PCI-SIG ENGINEERING CHANGE REQUEST

TITLE:	Display-Mini Card (DMC) Definition
DATE:	Updated April 02, 2009 (Initial request – July 21, 2008)
AFFECTED DOCUMENT:	PCI Express Mini CEM Revision 1.2
SPONSOR:	Ron Shaw, Dell Incorporated

Figure 2-3: Display-Mini Card Form Factor (Wireless Example Application Shown)

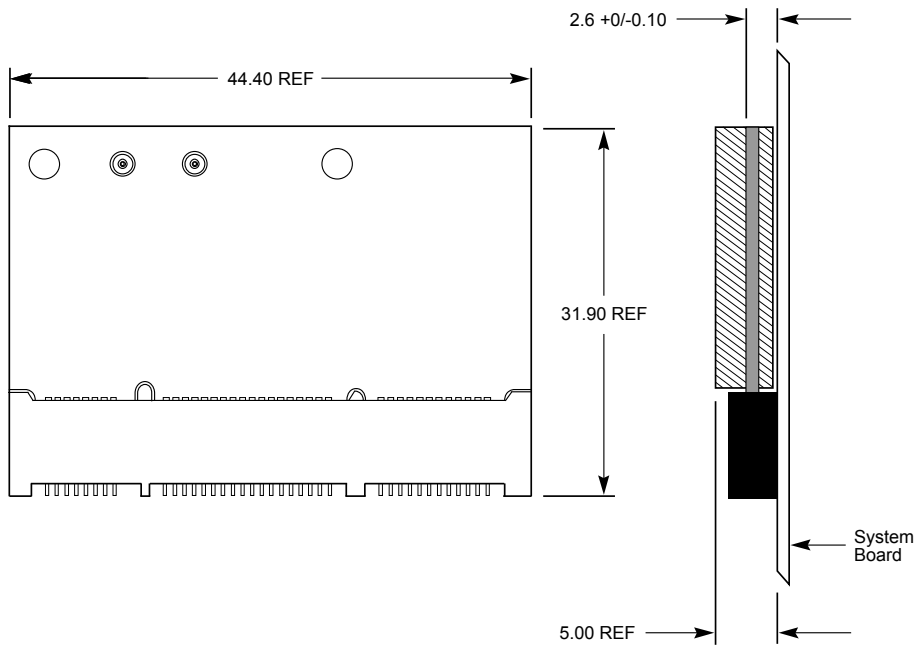
A new modified form factor, Display-Mini Card (DMC) based on the current Half-Mini Card (HMC, ver. 1.2) definition which adds additional pins and board space to allow for DisplayPort to be routed through the new connector.

- 10 1. A full DisplayPort (DP) interface will be added to the connector. This requires an additional 24 pins to provide the DP interface and DMC-specific signals.
2. The width of a DMC will increase by 14mm more than the current HMC to accommodate the additional 24 pins.
3. The power definition of the DMC will be increased to support the additional area and the projected requirement for future radio trends.
 - 15 a. Thermal will increase to 3.3 Watts
 - b. Electrical power delivery may increase.

15 A new form-factor, 44.40mm x 26.80mm, will be defined. A new connector to support the additional size and pins will be defined.

Figure 2-13: PCI Express Display-Mini Card System Connector

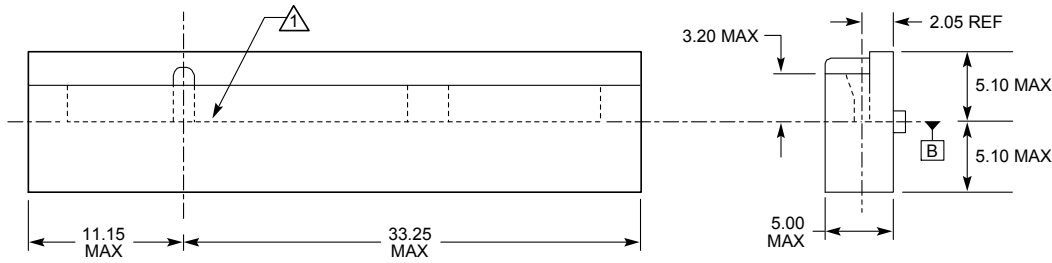
[The system connector for Display-Mini cards](#) is a 76-pin card edge type connector. Detailed dimensions should be obtained from the connector manufacturer. [Figure 2-13 shows this version of the system connector.](#)

Figure 2-20: Recommended System Board Layout for Dual-Use Display/Half-Mini Card Socket

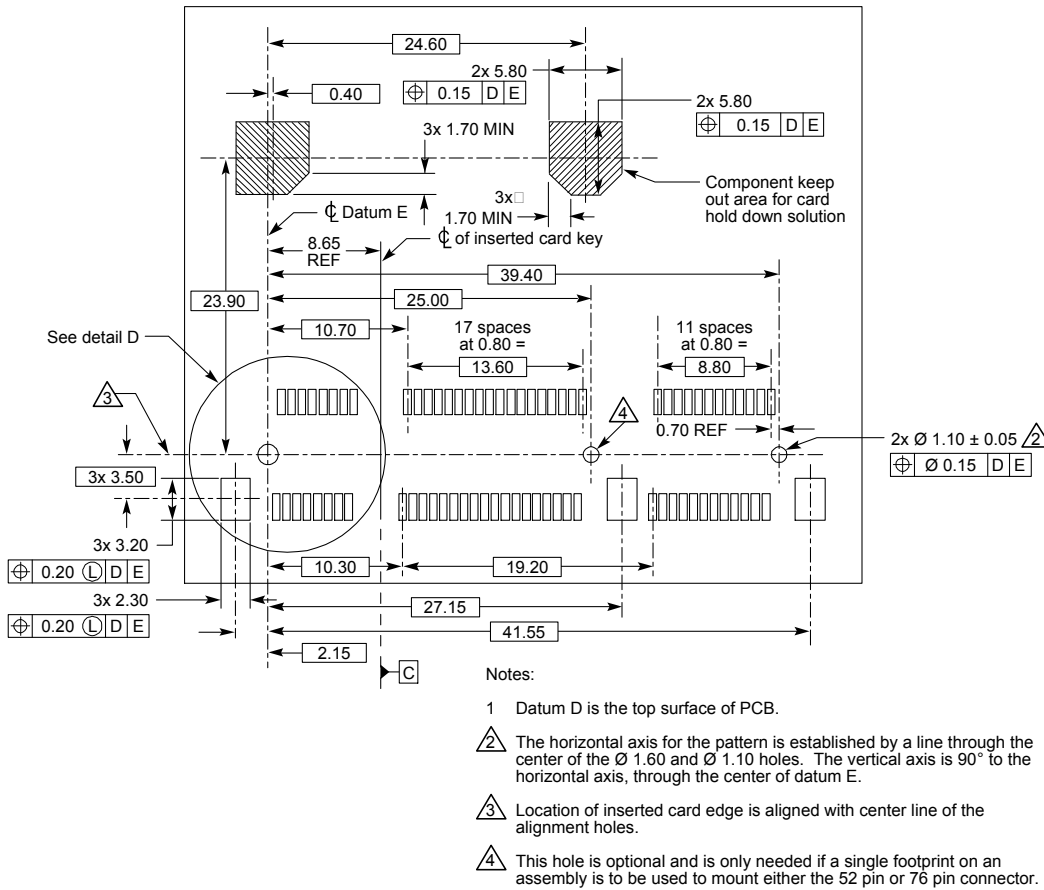
Figure 2-20 shows the recommended system board layout for a dual-use socket that can accept either a Display-Mini Card or a Half-Mini Card. While this socket uses the 76-pin system connector

specific to the Display-Mini Card application, the hold down support allows for the installation of a Half-Mini Card into the same socket. All Display and Half-Mini Cards are compatible with this socket.
